1001 JOHN ST

SEATTLE WA, 98109
DPD# 3020563

WEST DESIGN REVIEW BOARD:
DESIGN RECOMMENDATION 2 MEETING
JULY 13, 2016

Recommendation Response Comments Matrix

a **b** Screens along Terry Ave

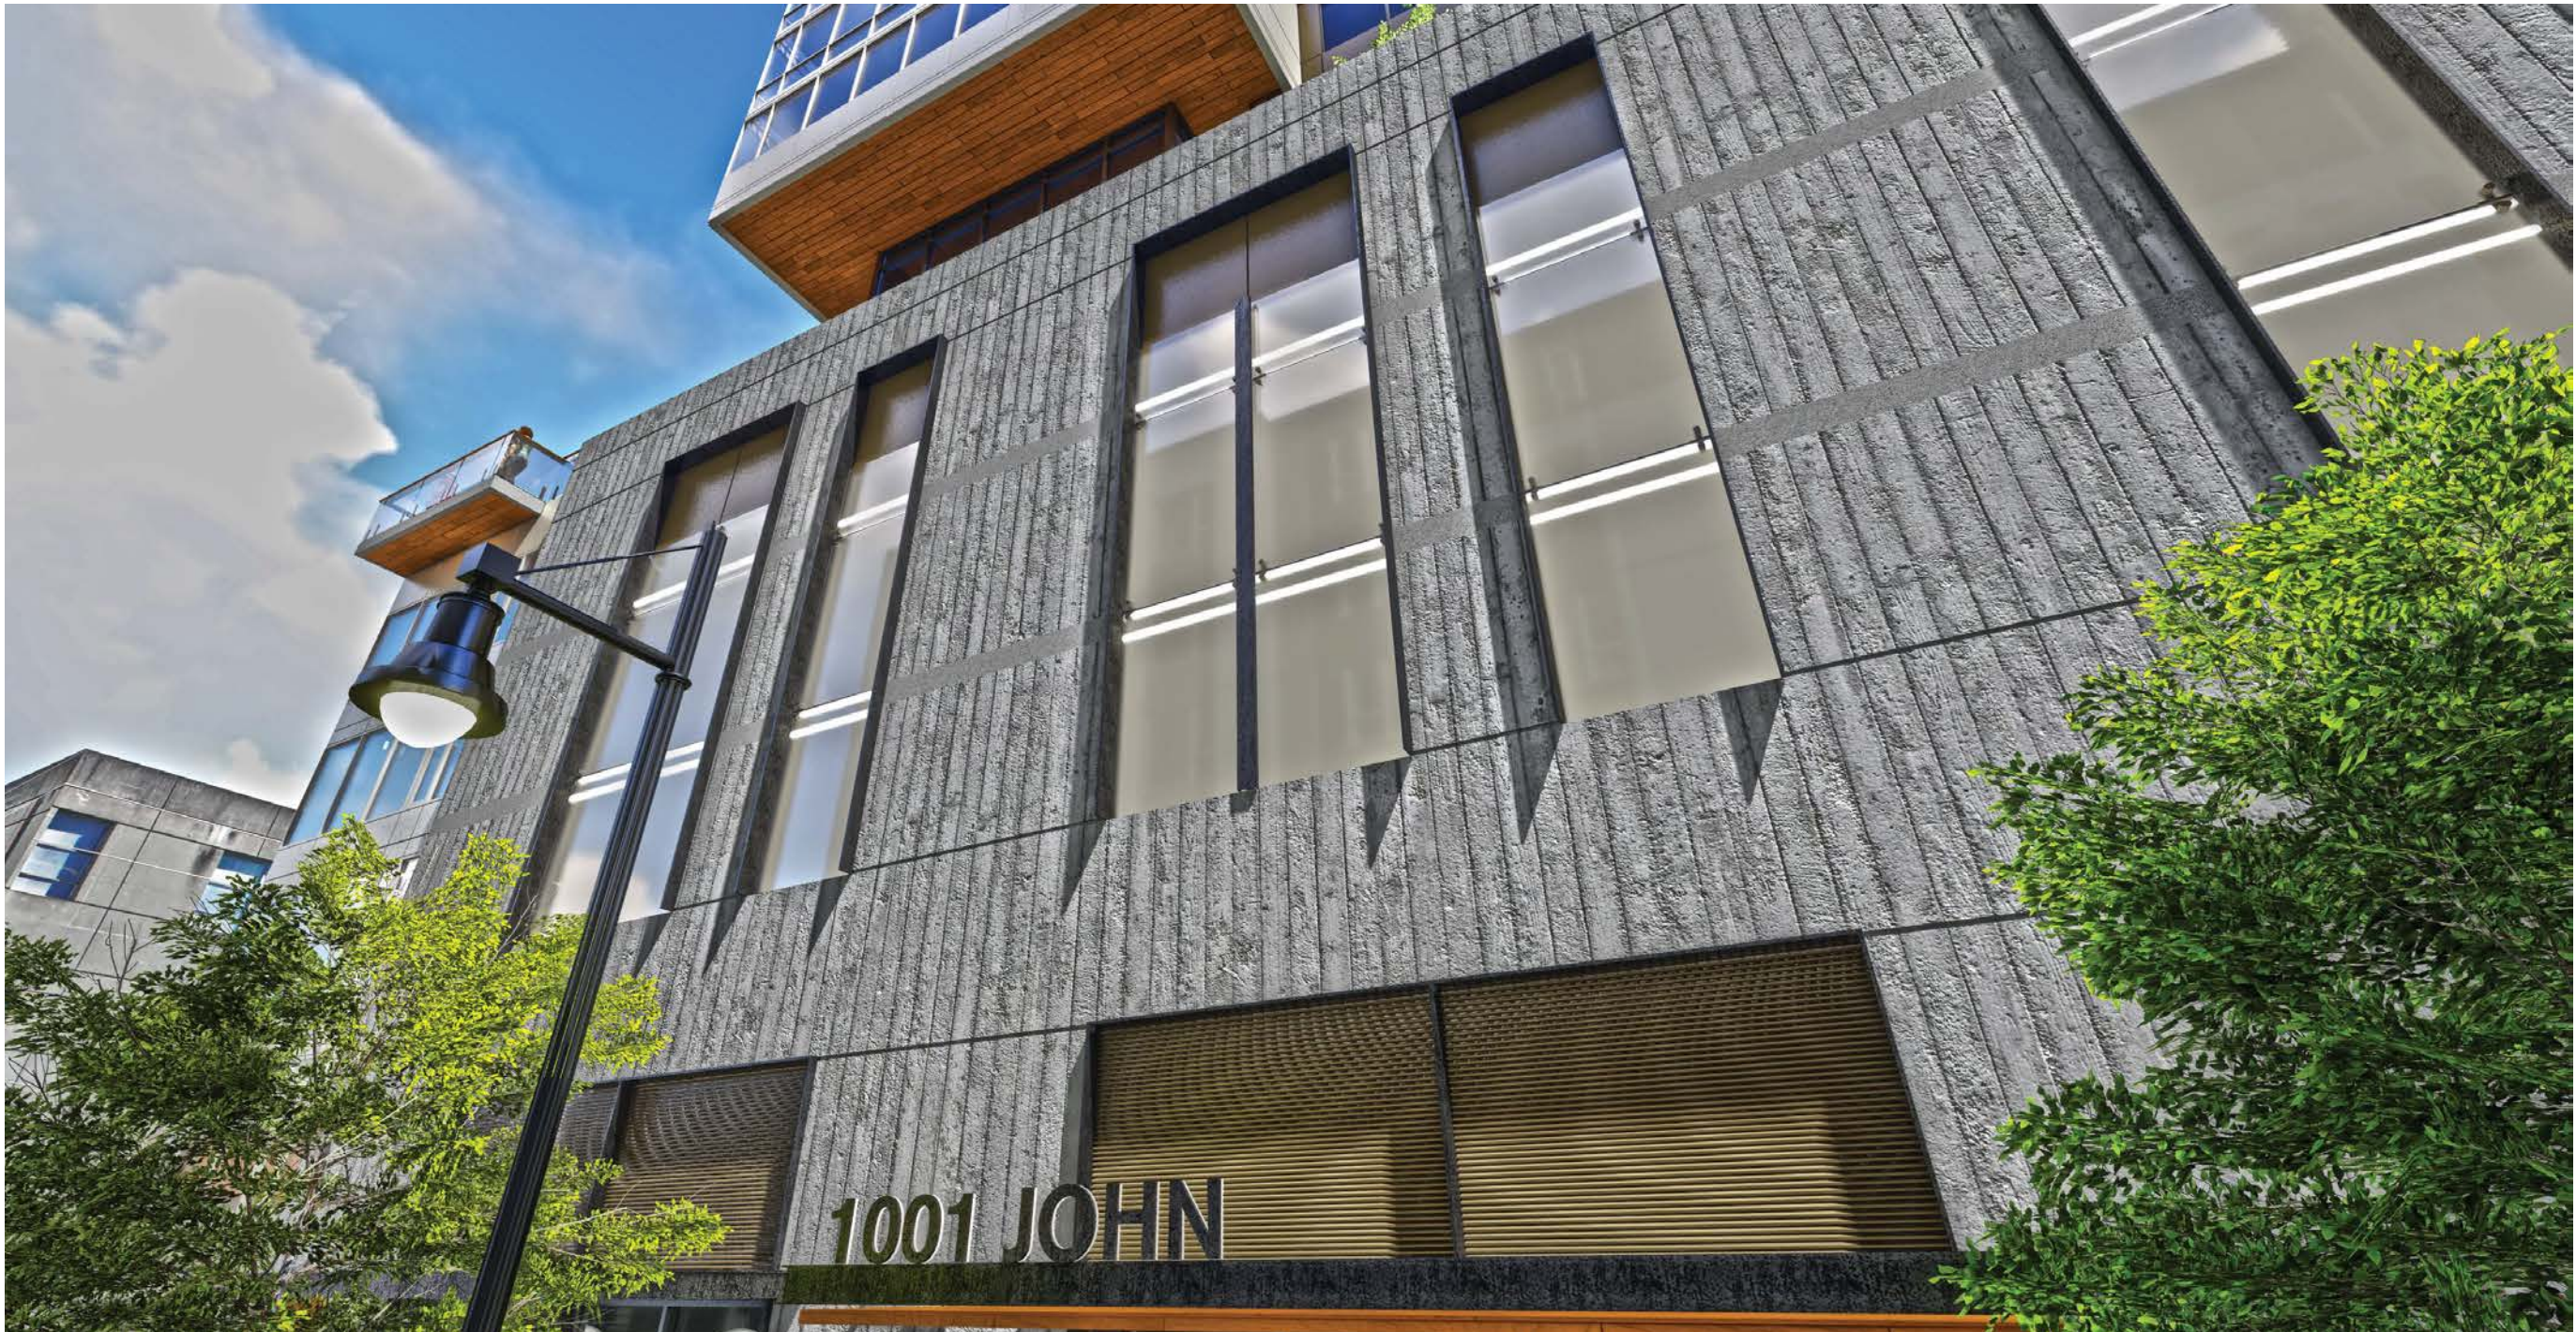
a. Provide greater depth at the framed opening of the screening and at the residential units. (DC2.D.1)	The board formed concrete podium is fenestrated with vertically proportioned openings and pilasters reminiscent of the Seattle Time building. Bronze painted metal panels, relating to the tower above, are located at the top of the vertically proportioned garage openings and will be recessed 6” from the face of the concrete. Black steel channels will project 6” from the face of concrete creating a 12”recess at that condition.

b. Design the metal screening with depth or historical reference. (CS3.II.iv, DC2.D.1)	Fritted, translucent glass panels, relating to the elevator tower, will be backlit at the jambs and front lit at the panel centers. The panels will be set into the metal frames and 6” inboard from the steel channels for relief.

East Fin Termination

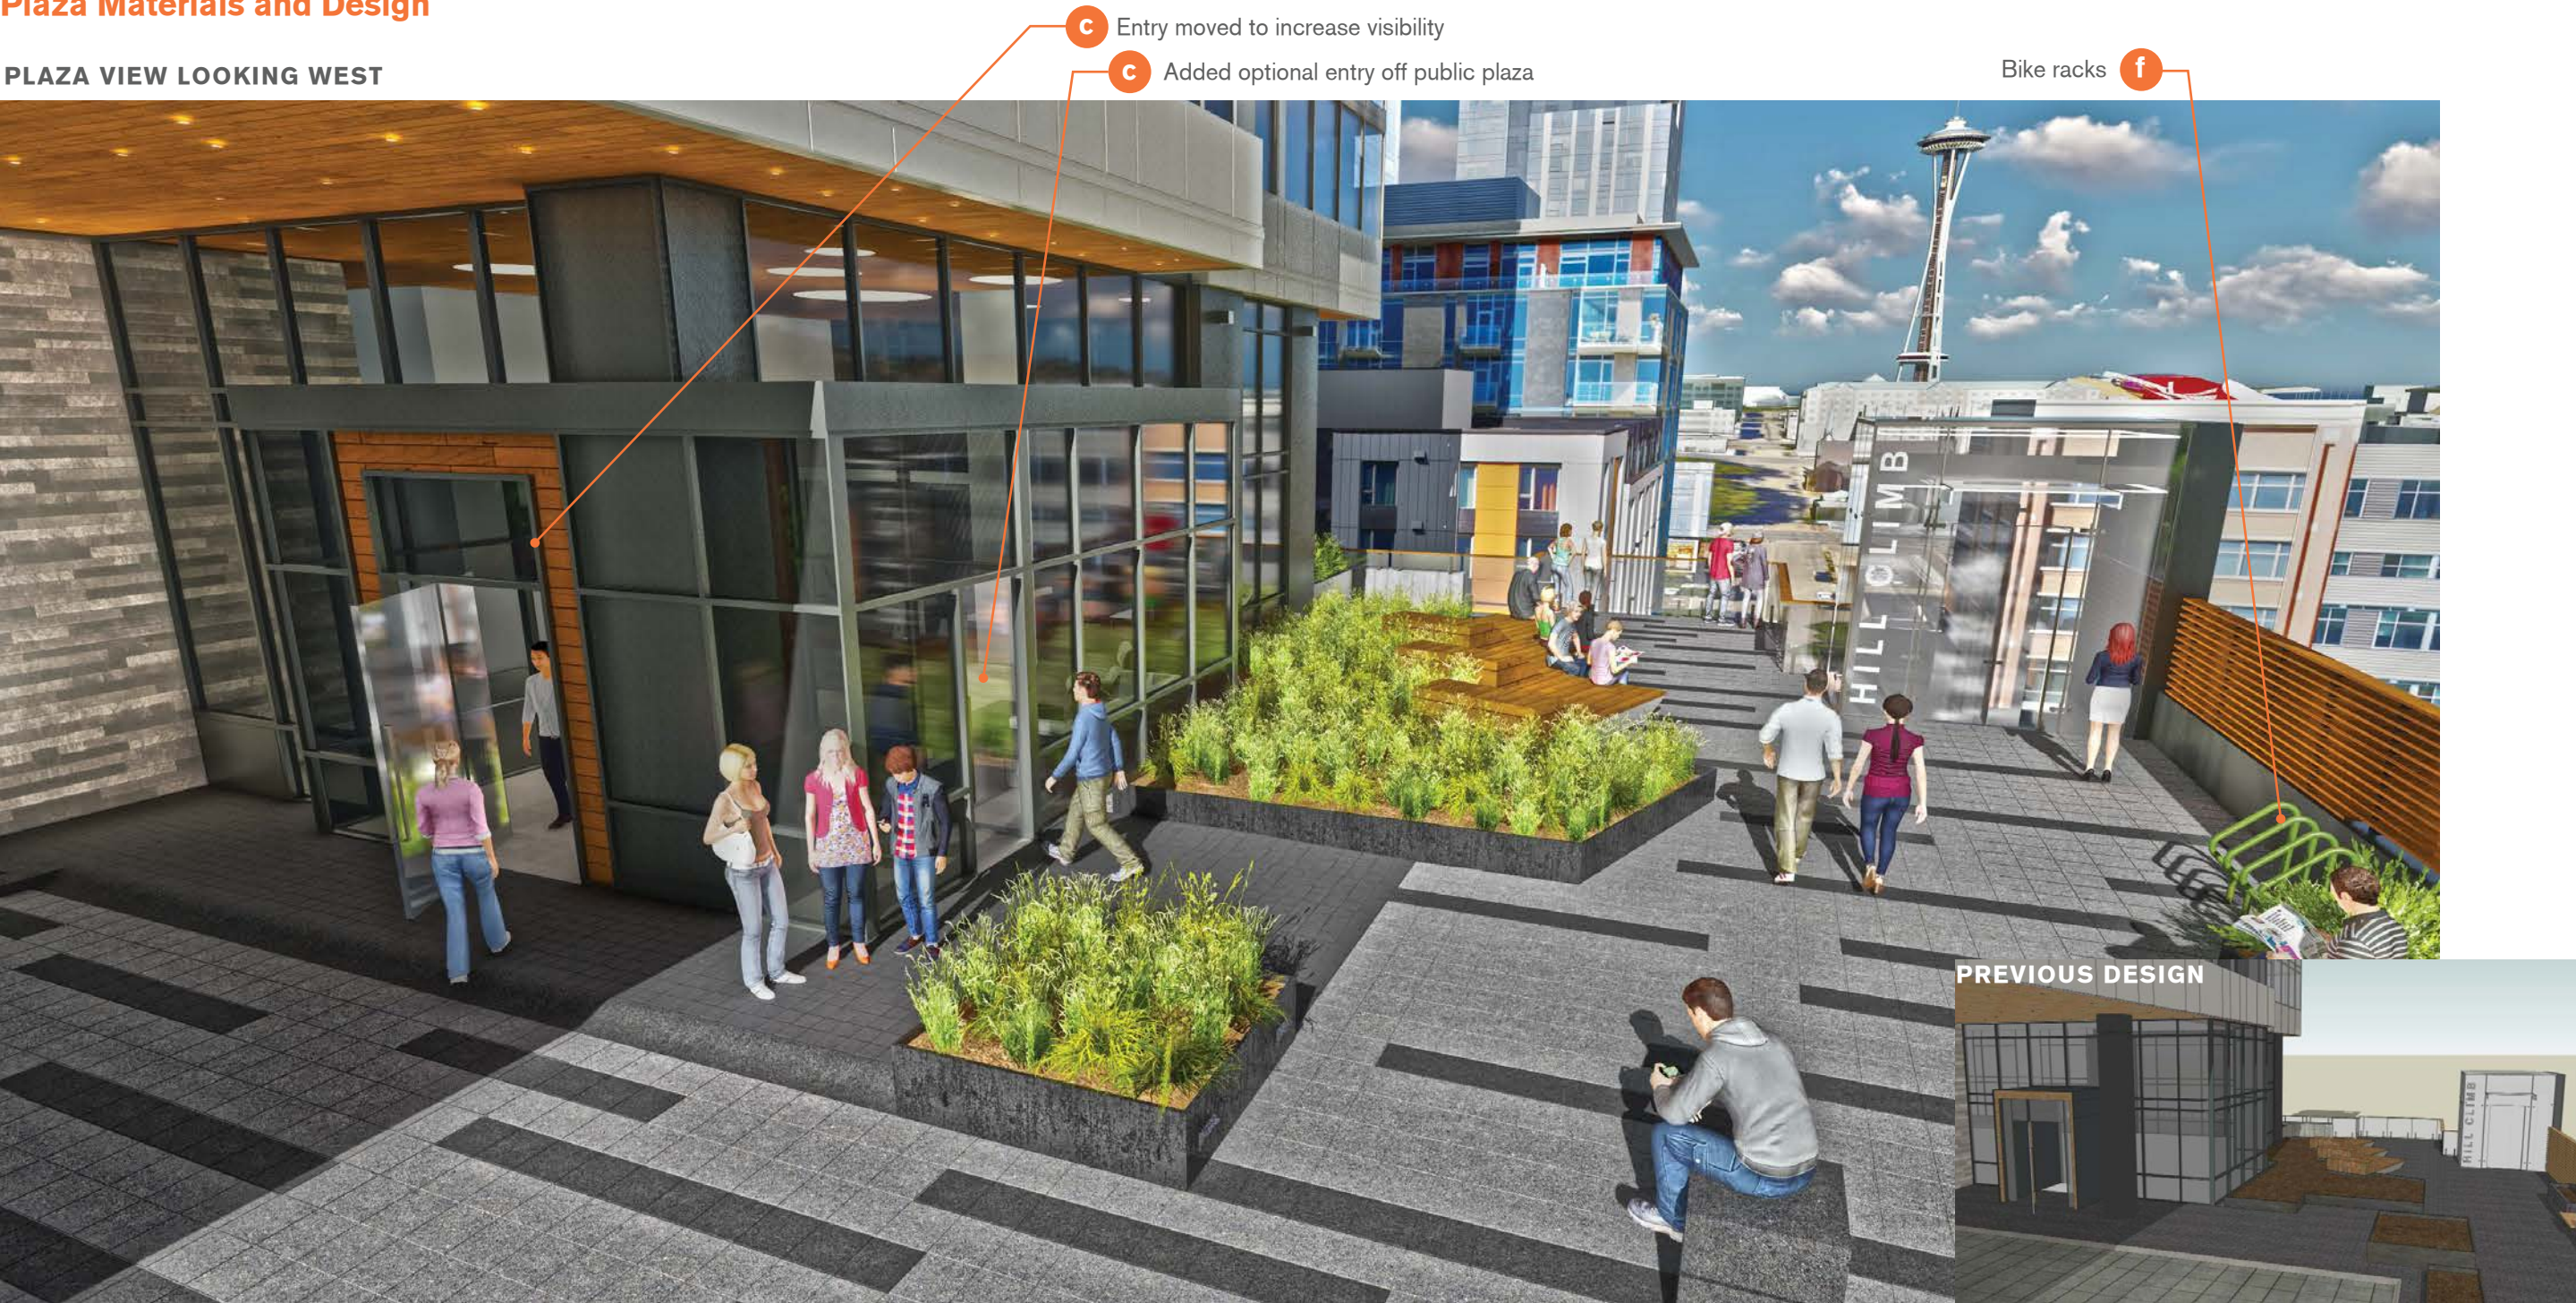
e. Resolve the termination of the vertical fin on the east elevation. (DC2.B.1)	The vertical fin will tie into the lighter colored metal fascia at the drop-off soffit.

e Fin terminates at soffit

6 Tower Separation 23.48.245
Proposed Departure Condition

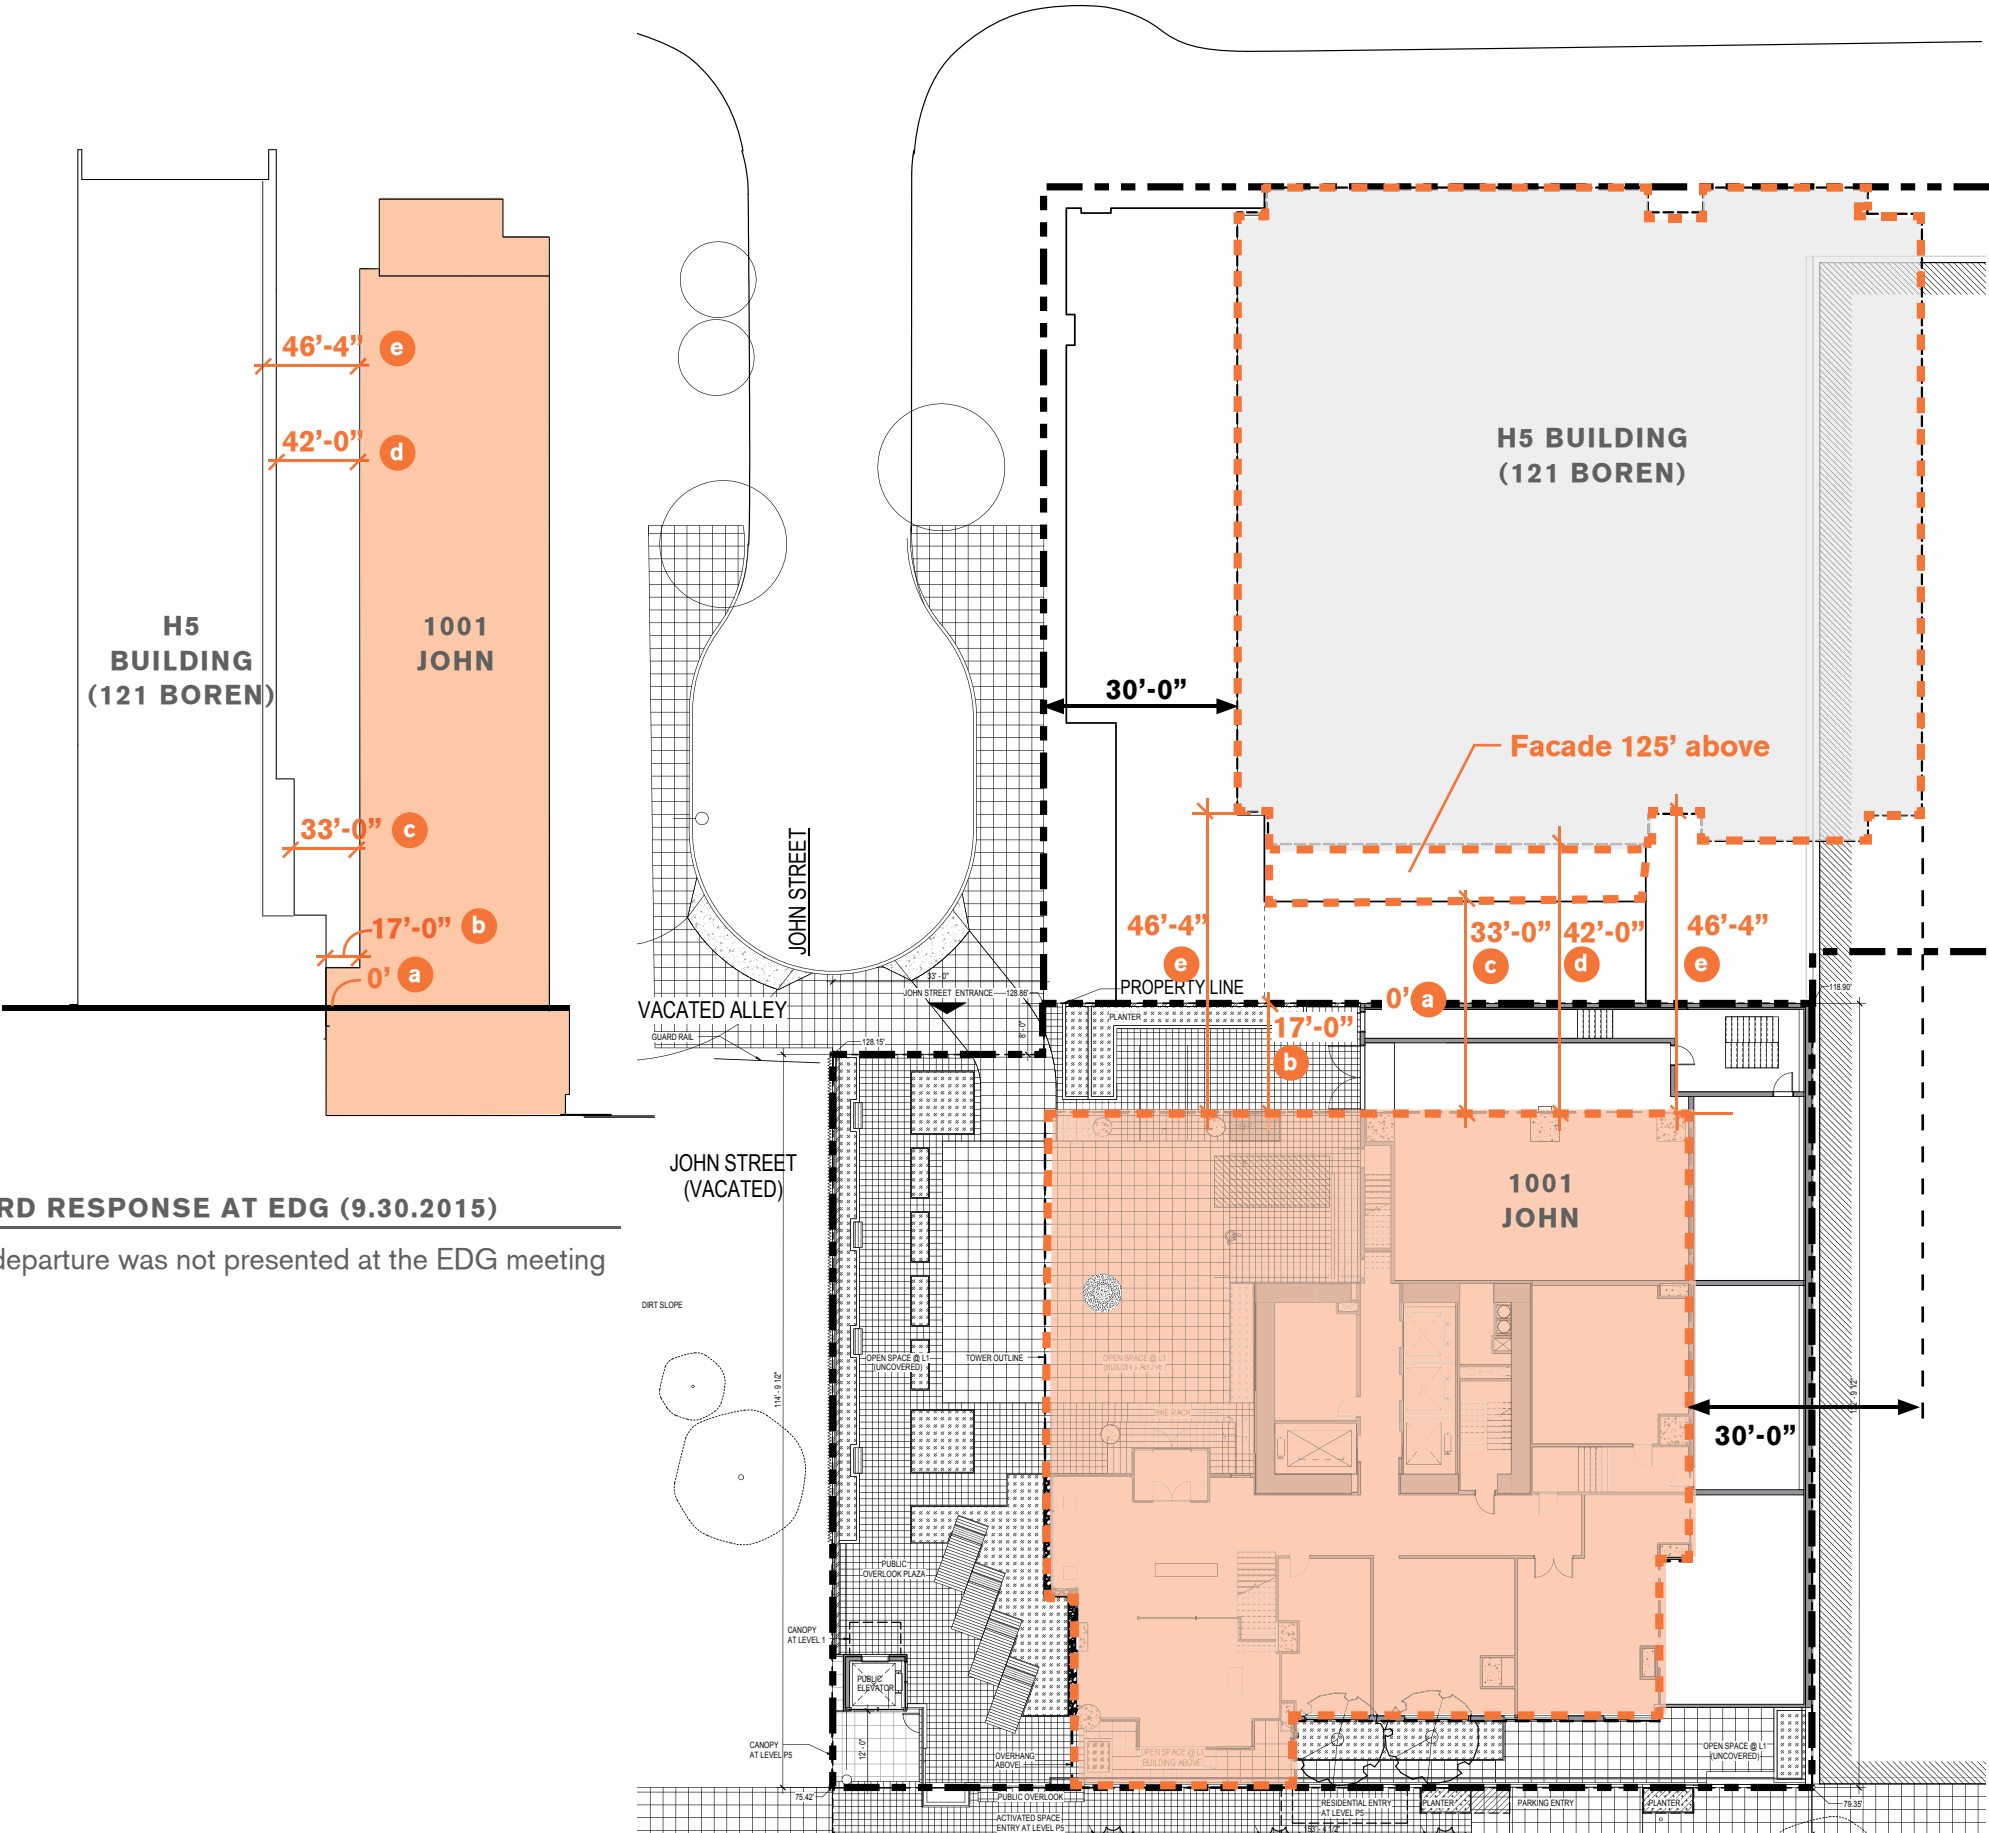
Per SMC 23.48.245.G, a separation of 60 feet is required between all portions of residential structures above the podium height limit (45 feet) for structures with residential uses above the base height limit located on the same block. A Master Use Permit (MUP) application has been submitted on an adjacent development site within this block. Based on the MUP application information available to SDCI, the tower separation standard is not met. Please modify the design to achieve the required tower separation or include a departure request to allow a reduced tower separation.

Tower separation less than 60' based on latter applicant's H5 Tower location (121 Boren #3021279). The project requests the following tower setbacks from 121 Boren (H5 Tower):

- a. 0'
- b. 17'
- c. 33'
- d. 42'
- e. 46'-4"

Following the direction from our EDG meeting and the design review board we have kept the tower out of the vacated John Street ROW. Along with staying out of the vacated John Street ROW we have voluntarily moved the tower as far west 7' and north 5' as we can to separate it from the property to the east (H5 Development project #3021279). The result of this tower move eliminated half of the residential units in the podium levels. Due to the size and geometry of our site there are very few tower location options and these were presented at our EDG meeting. The proposed tower stands 17'-0" off the east property line and 15' or more off the south property line. Based on the drawings submitted by H5 on 3-23-16, this would create a tower separation of 42' and 46' above 125' and 33' separation below 125'. Tower separation could change if H5 revises their design. Towers are currently offset 30' north/south.
